# Access Compliance Report

## Public Rights-of-Way

### (Curb Ramps)

Intersection ID: 18641	Main Street: PORTBURN_RD	Cross Street: RAMA_RD	Location:	N
ADA ID: 54DE2B388439	Ramp Type: PerpDiag	Initial Pass/Fail: Fail	Overall Compliance: No	Severity Score: 25

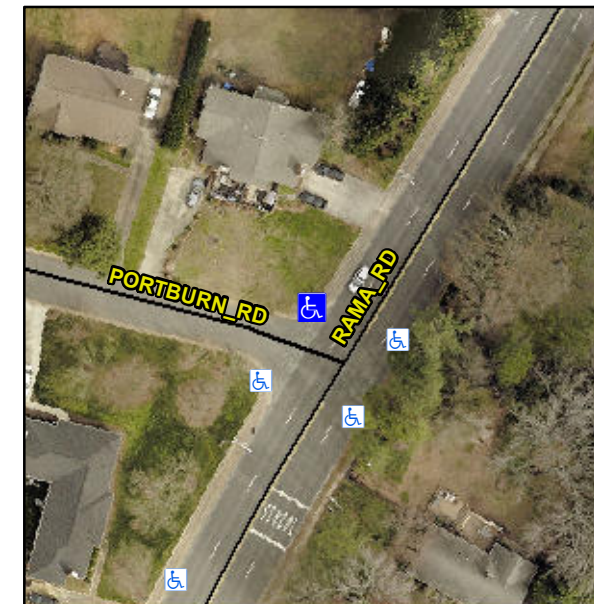
**Not Found, R304.5.3**

Compliance	Description	Data	Compliance	Description	Data
N/A	Ramp Length (in)	58.0	Yes	Ramp Slope (%)	7.8
Yes	Ramp Width (in)	48.0	No	Ramp XSlope (%)	7.9
N/A	Flare Type LT	N/A	N/A	Flare Type RT	N/A
N/A	Flare Slope LT (%)	N/A	N/A	Flare Slope RT (%)	N/A
N/A	Flare Traversable LT?	N/A	N/A	Flare Traversable RT?	N/A
N/A	Landing Length (in)	N/A	N/A	DWS Provided?	N/A
N/A	Landing Width (in)	N/A	N/A	DWS Contrast?	N/A
N/A	Landing Slope (%)	N/A	N/A	DWS Length (in)	N/A
N/A	Landing X Slope (%)	N/A	N/A	DWS Full Width?	N/A
N/A	Landing Curb? (Y/N)	N/A	N/A	DWS Offset (in)	N/A
N/A	Shared Landing?	N/A			
N/A	Gutter Ponding?	N/A	N/A	Gutter Slope (%)	N/A
N/A	Gutter Lip Ht (in)	N/A	N/A	Gutter X Slope (%)	N/A
N/A	Painted X Walk1?	No	N/A	Painted X Walk2?	No
	X Walk 1 Direction	To SW		X Walk 2 Direction	To SE
N/A	X Walk 1 Width (in)	N/A	N/A	X Walk 2 Width (in)	N/A
	X Walk 1 Slope (%)	2.7		X Walk 2 Slope (%)	1.4
	X Walk 1 X Slope (%)	2.0		X Walk 2 X Slope (%)	2.3

**Remove & Replace Curb Ramp With Two New Directional Ramps or Equivalent.**
